METROPOLITAN GOVERNMENT OF NASHVILLE AND DAVIDSON COUNTY

STAFF RECOMMENDATION
1813 Blair Boulevard
May 21, 2014

Application: Demolition—Primary structure and outbuilding; New Construction—
Duplex infill and outbuildings

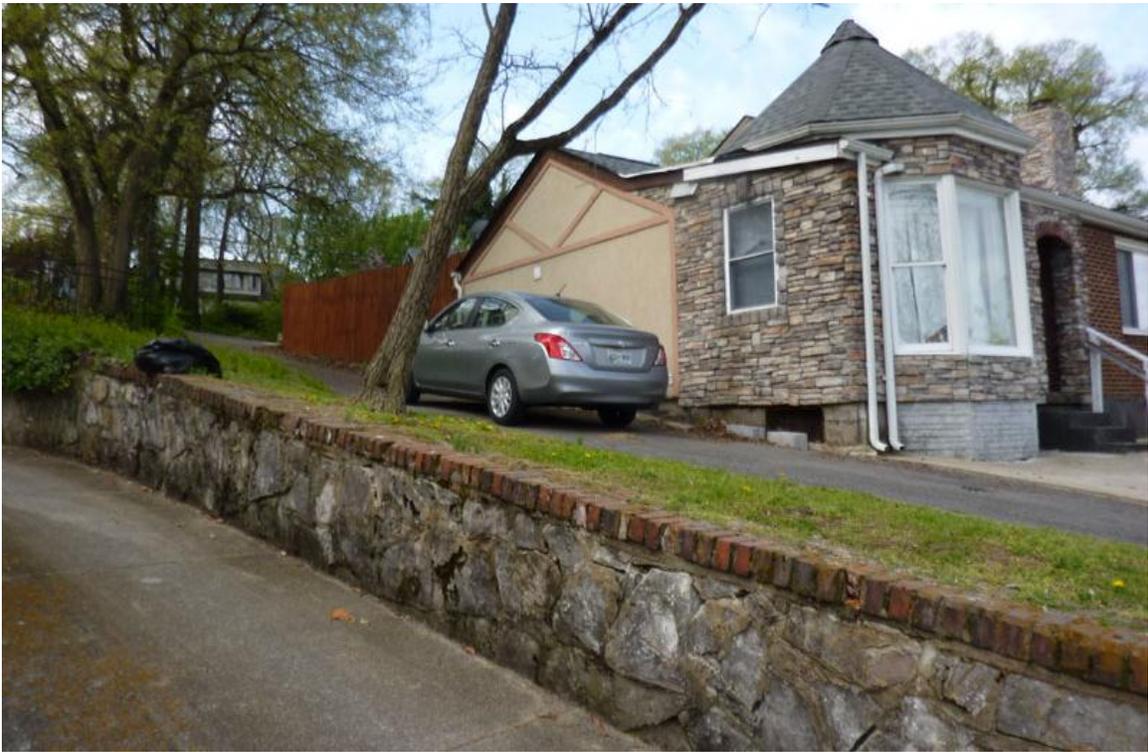
Background: 1813 Blair is a c. 1950 brick house (Figure 1). The structure’s materials, form, detailing, and construction date are not consistent with the historic character of this part of the Belmont-Hillsboro Neighborhood Conservation Zoning Overlay. The structure is therefore considered to be non-contributing to the overlay. The lot is steeply sloped from the front to the back of the lot. There is about a twenty foot (20’) difference in grade from front of the lot to the back.

Figure 1. 1813 Blair Boulevard is a non-contributing house. The lot slopes steeply from front to back.

A001

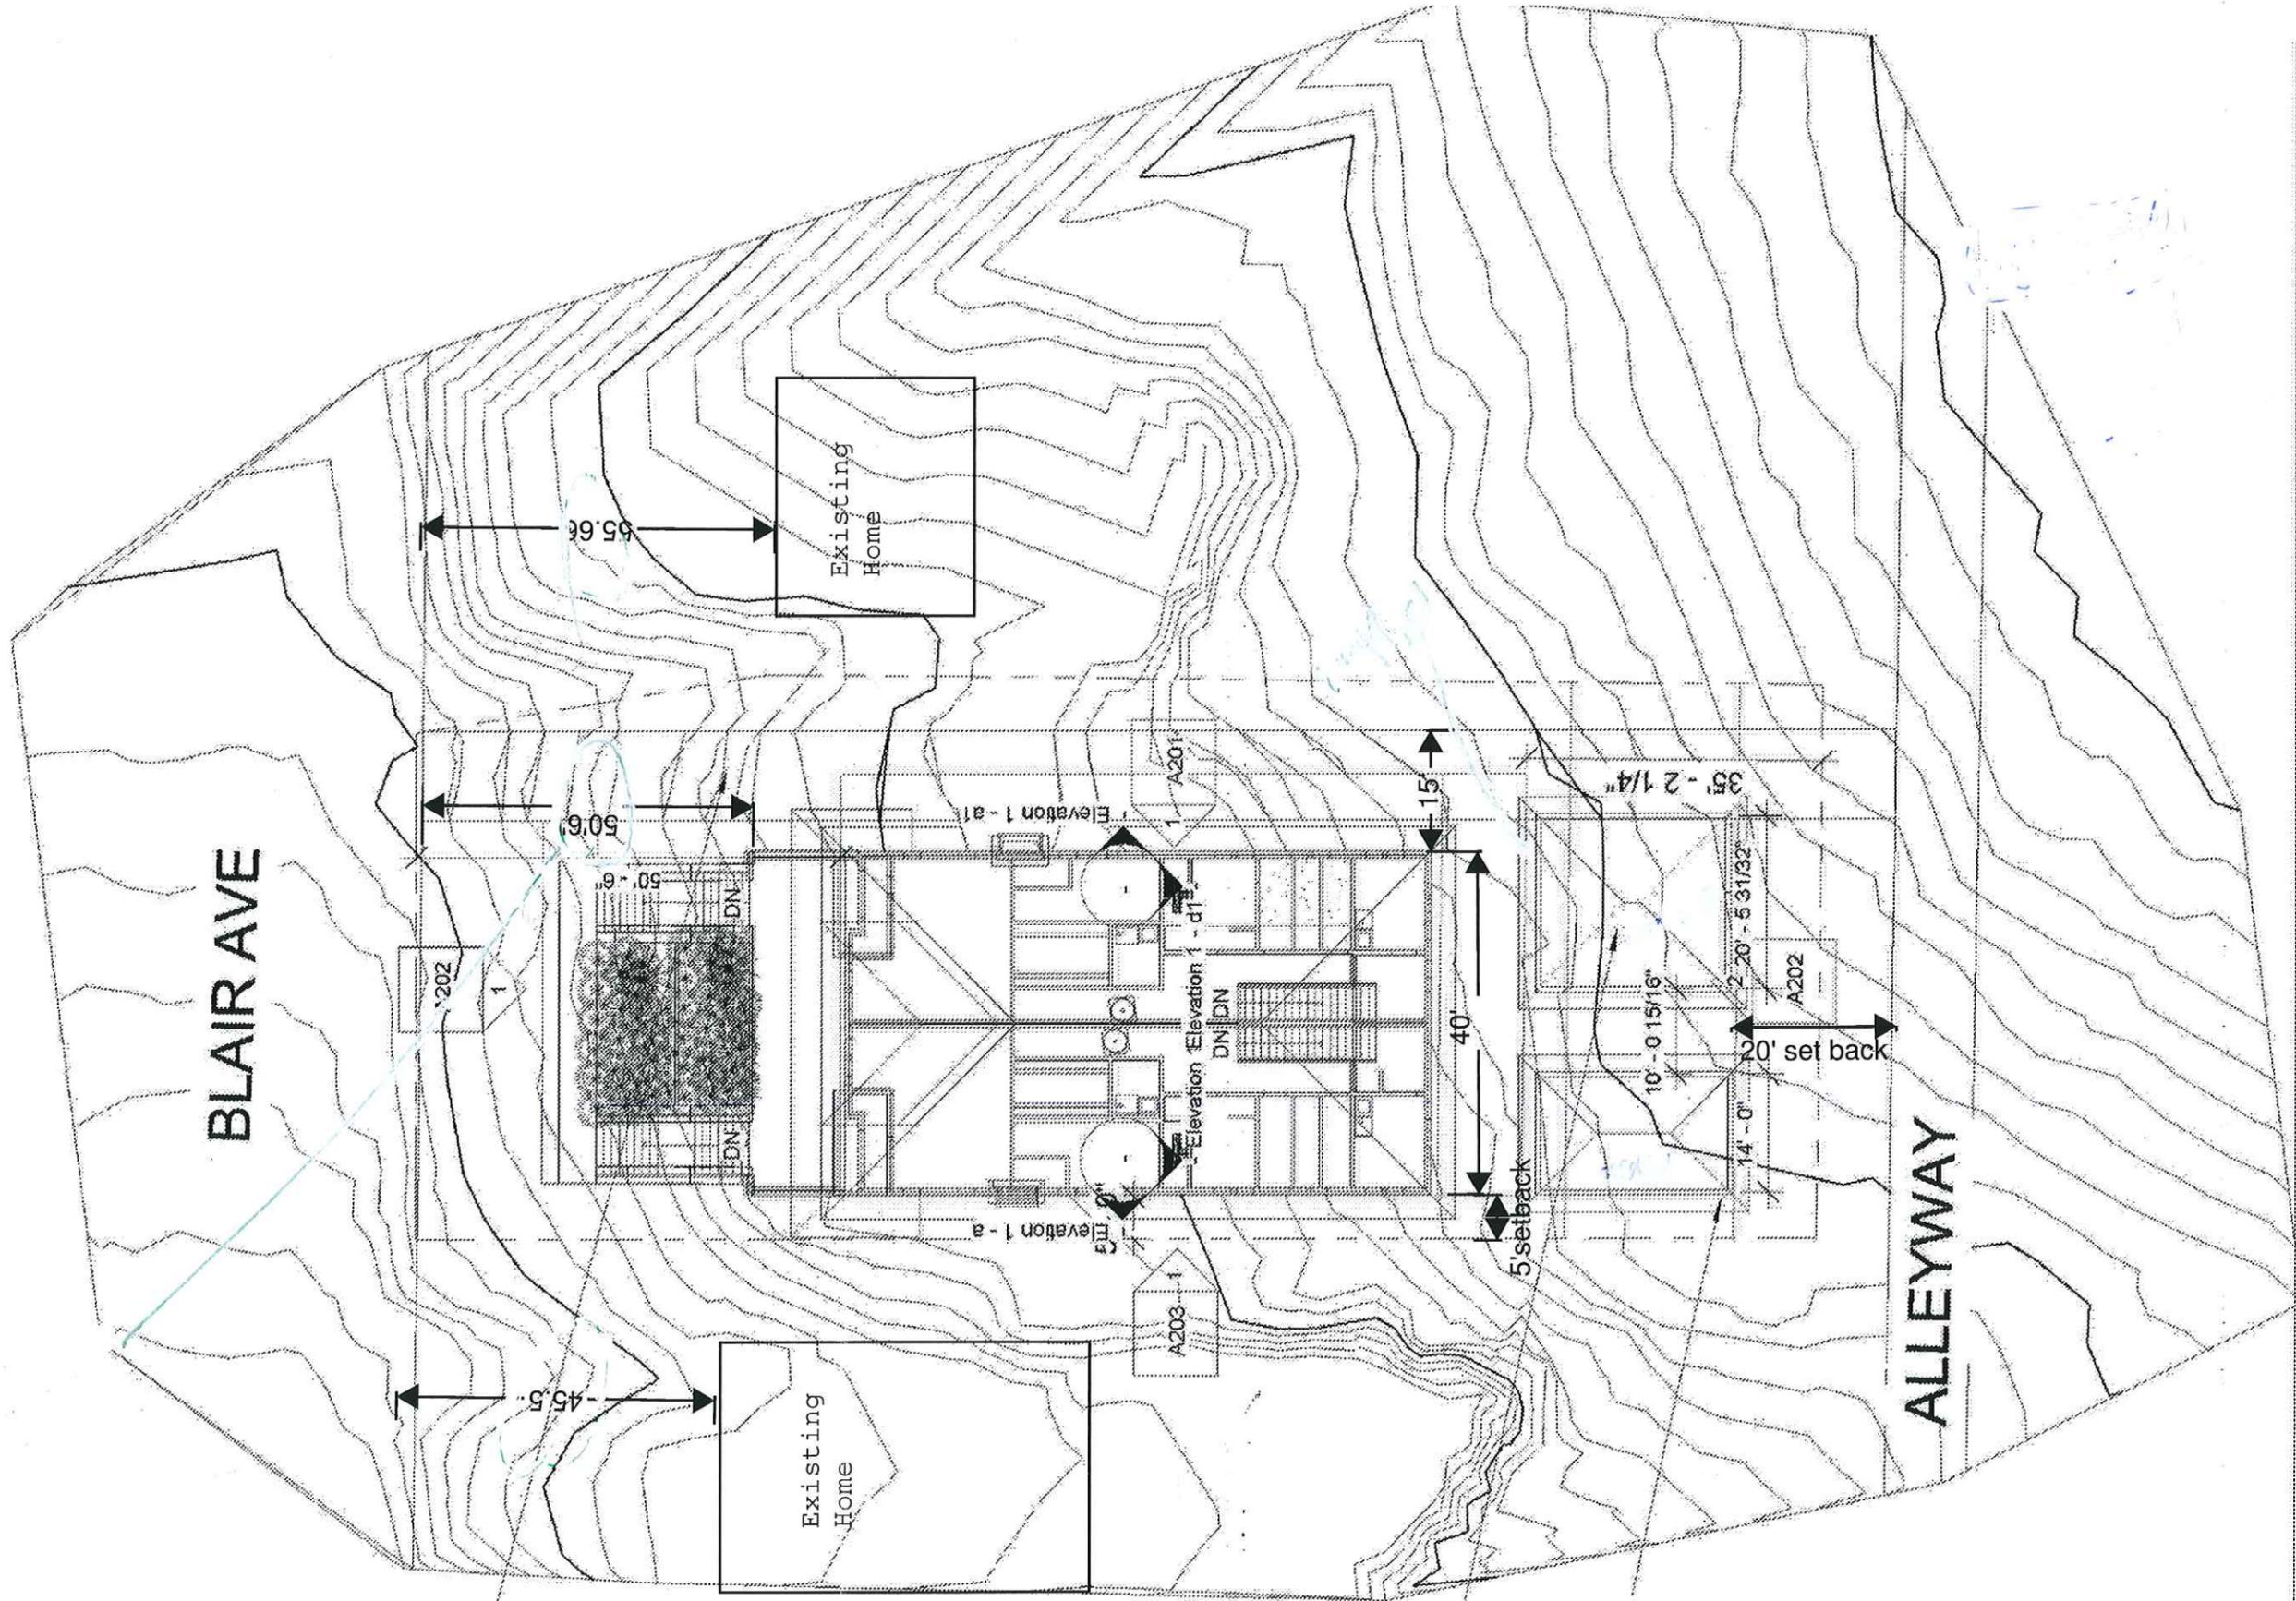
Setback & Rhythm of Spacing: The new duplex infill will meet all base zoning setbacks. According to the site plan label, the infill will be fifty feet, six inches (50'6") from the front property line, which is the average of the front setbacks for the two flanking historic structures. Staff notes when measuring the site plan, the drawing shows that structure is located just forty feet (40') from the front property line. An accurate site plan is required before approval of the project should be granted. The infill will be

located five feet (5') from the west property line and fifteen (15') from the east property line. This could allow for the retention of the existing driveway on the site, but the driveway is not indicated on the site plan. If the infill is indeed situated fifty feet, six inches (50'6") from the front property line, staff finds that the structure's setback and rhythm of spacing meet section II.B.1.c. of the design guidelines.

1813 BLAIR BLVD
 ELEVATION
 A201

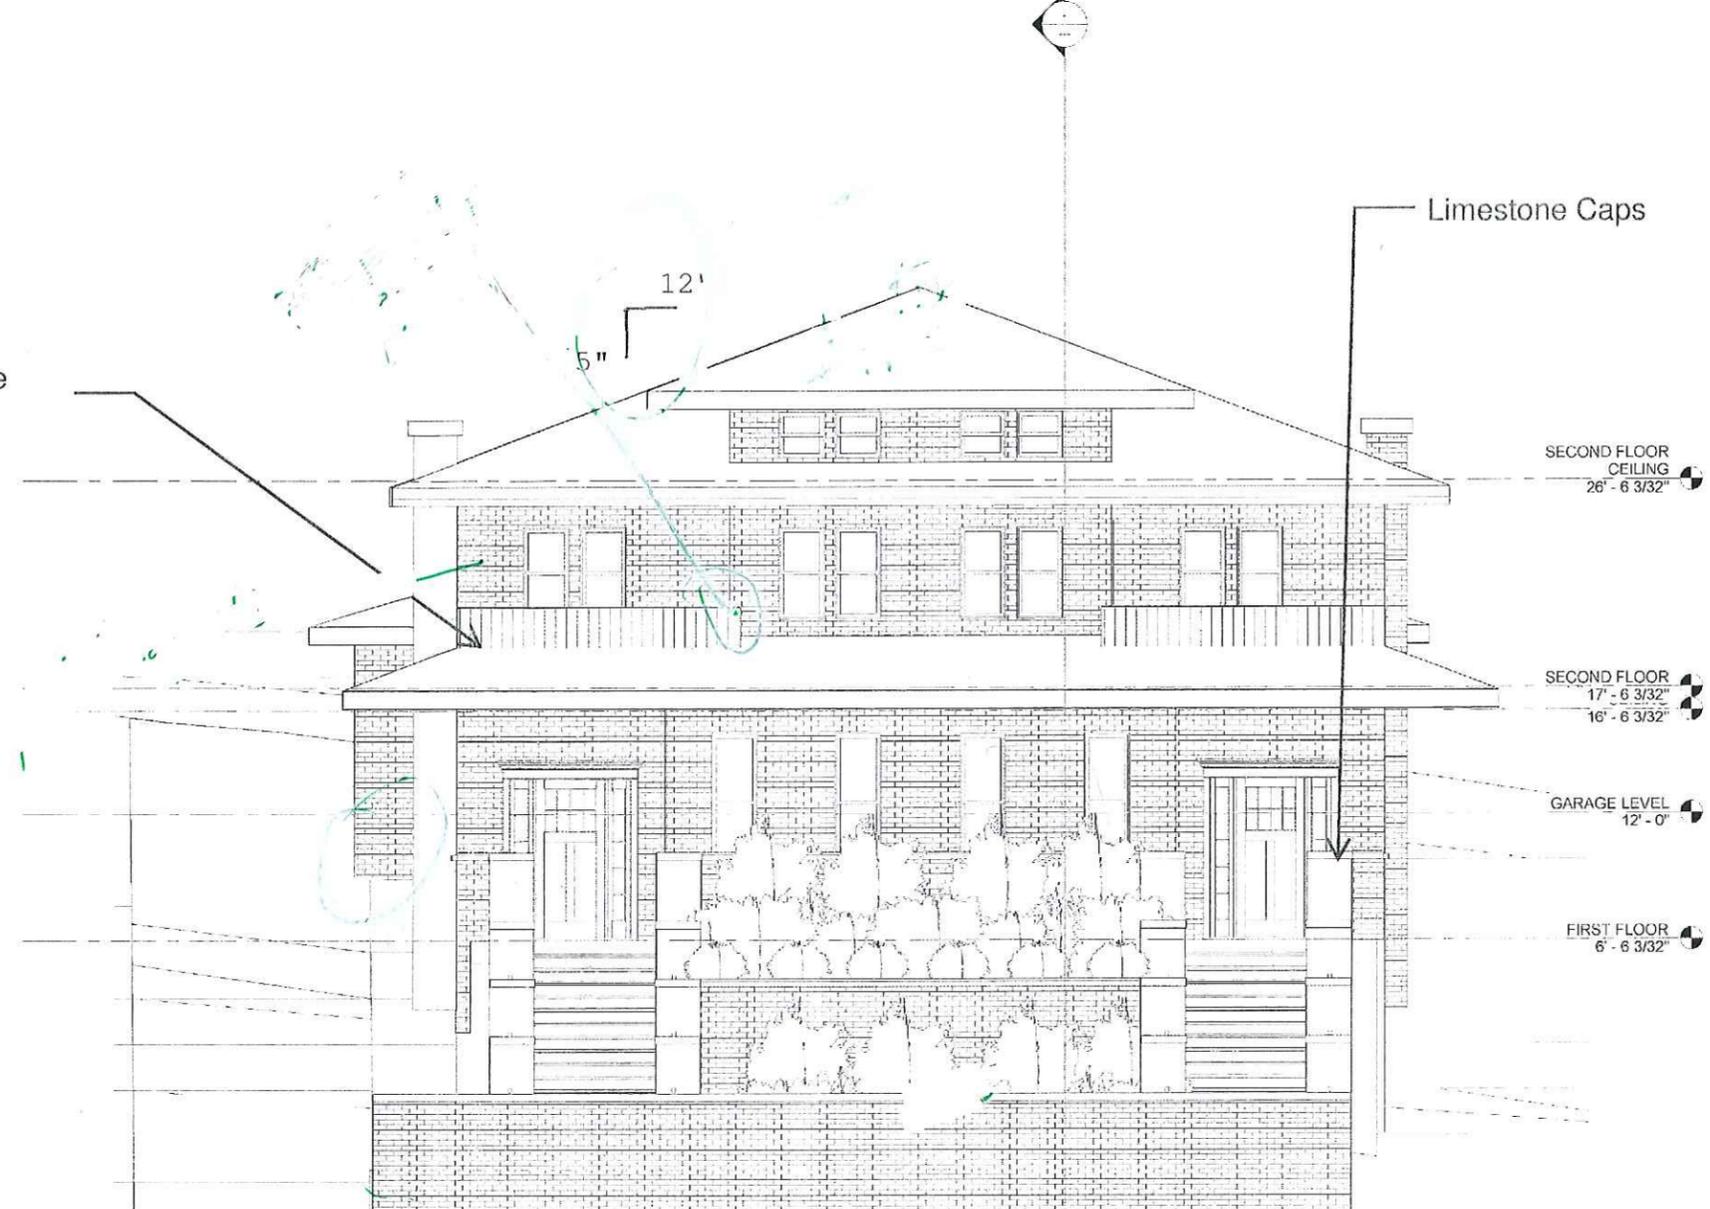
Height & Scale: Because of the steep slope of the site, the height of the structure varies depending upon the grade. At the front, the structure seems to have a porch eave height of approximately twelve feet (12'), an eave height of about twenty feet, six inches (20'6"), and a ridge height of approximately thirty feet (30'). Staff finds that the ridge height matches the historic context, where heights range from twenty to forty-two feet (20' – 42'). The foundation height could not be determined by the drawings. Although the site plan indicates that the structure is forty feet wide (40'), the floor plans and elevations show that it is forty-one feet (41') wide. Assuming the structure is forty feet (40') wide, staff finds the width to be appropriate since the lot is sixty feet (60') wide, and the historic houses in the immediate vicinity range from thirty-five to sixty feet (35'-60') wide. The front elevation shows a bay, which would further widen the structure. The bay does not appear on the side façade drawing. Staff finds that the added width of the bay is not appropriate. The structure will be approximately seventy feet (70') deep. With the staff's review of the foundation height and the removal of the side bay(s), staff finds that the structure's height and scale meet section II.B.1.a. and b. of the design guidelines.

Roof form: The infill's primary roof form is a hipped roof with a 5/12 slope. The design guidelines state that roofs should typically have a slope of 6/12. Staff, however, finds the 5/12 slope to be appropriate in this instance because prairie-style, lower sloped roofs with large eave overhangs like this one are found in the Belmont-Hillsboro Neighborhood Conservation Zoning Overlay, most noticeably at 2616 Belmont Boulevard. The infill includes a large front dormer, which staff finds to be out of scale with typical front dormers. The dormer is seventeen feet (17') wide, meets the ridge of the house, and is not set back from the wall below it. Staff finds that the dormer would have to be significantly reduced in width, would have to be moved off the ridge by two feet (2'), and would have to be set back two feet (2') from the wall below in order for it to meet the design guidelines. Because of the front dormer, staff finds that the infill's roof does not meet section II.B.1.e. of the design guidelines.

Orientation: The duplex is oriented to face Blair Boulevard, and it has two slightly recessed doorways on the front façade. The doorways are recessed approximately eighteen inches (18") from the primary façade of the house. The entries have equal prominence, which is typical of historic duplexes. The duplex has a full width front porch that is a minimum of six feet (6') deep. Staff notes that the porch is part of a larger platform that is ten feet (10') deep, although only six feet (6') of that is covered.

The front façade has two second-story covered balconies that are each over six feet (6') deep. The duplex's façade behind the balconies are recessed five feet (5') from the primary wall of the house. Staff finds that this type of second story, deep balcony that requires the front wall to be significantly recessed is not found on historic structures in the Belmont-Hillsboro neighborhood. The result of the large second story balconies is the appearance of a two-story covered porch, which is not appropriate. Because of the inappropriateness of the second story balconies, staff finds that the project's orientation does not meet section II.B.1.f. of the design guidelines.

A202

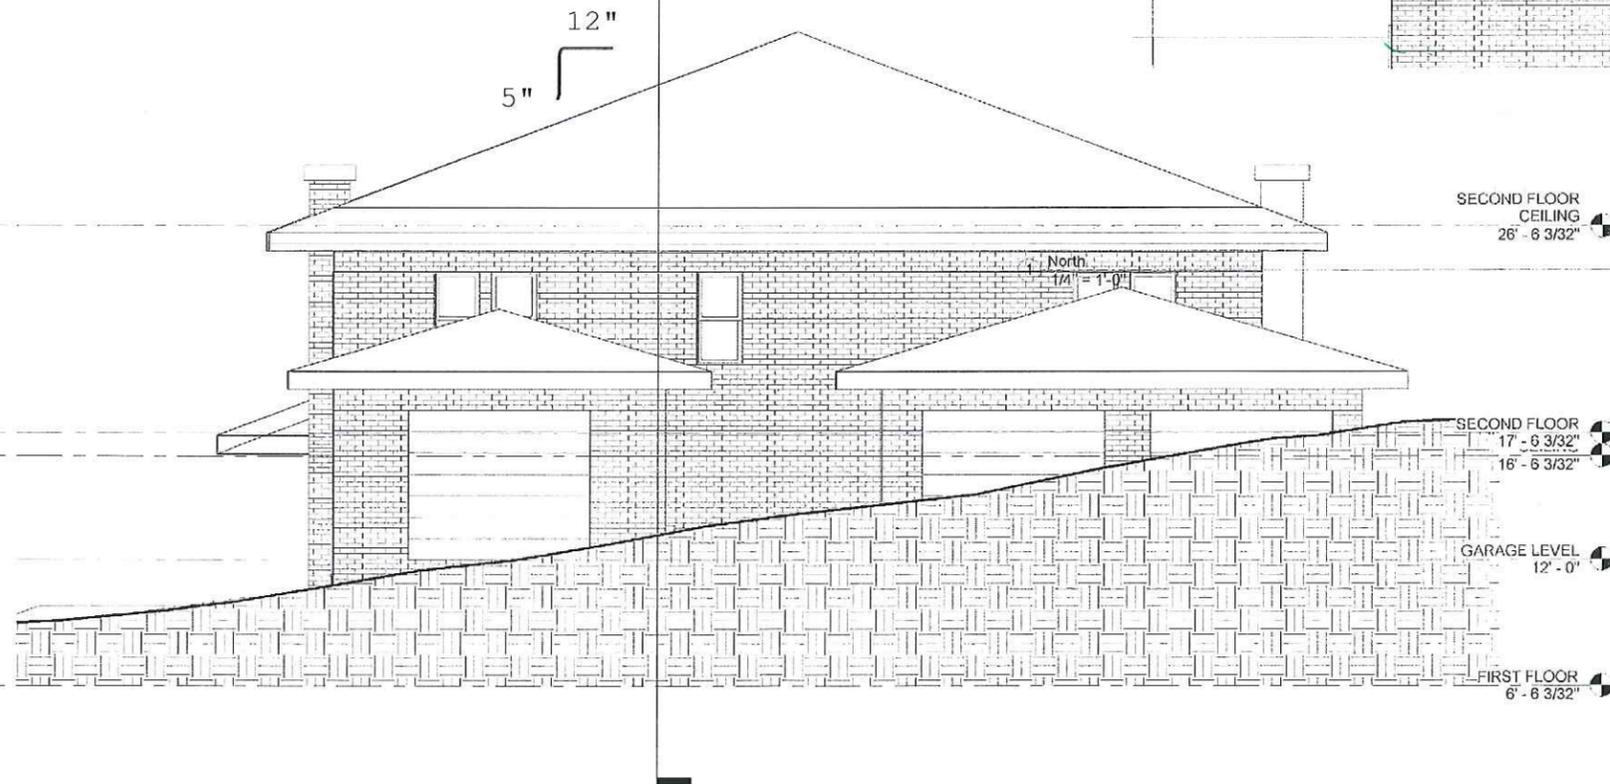
Proportion and Rhythm of Openings: The window openings on the front façade are generally at least twice as tall as they are wide and meet the historic proportion of window openings. On the side façade, the windows do not meet the typical rhythm of openings for historic structures. (This analysis assumes that the two side facades are identical, as only one side façade drawing was submitted). On the ground floor, a window of at least four square feet is required behind the front wall of the house. On the second floor, the large glass door accessing the balcony is not appropriate, particularly this close to the front façade of the house. Also on the second level, there are several large expanses of wall space without a door or window opening, and staff asks that more windows be added. Staff finds that the project's proportion and rhythm of openings do not meet Section II.B.1.g. of the design guidelines.
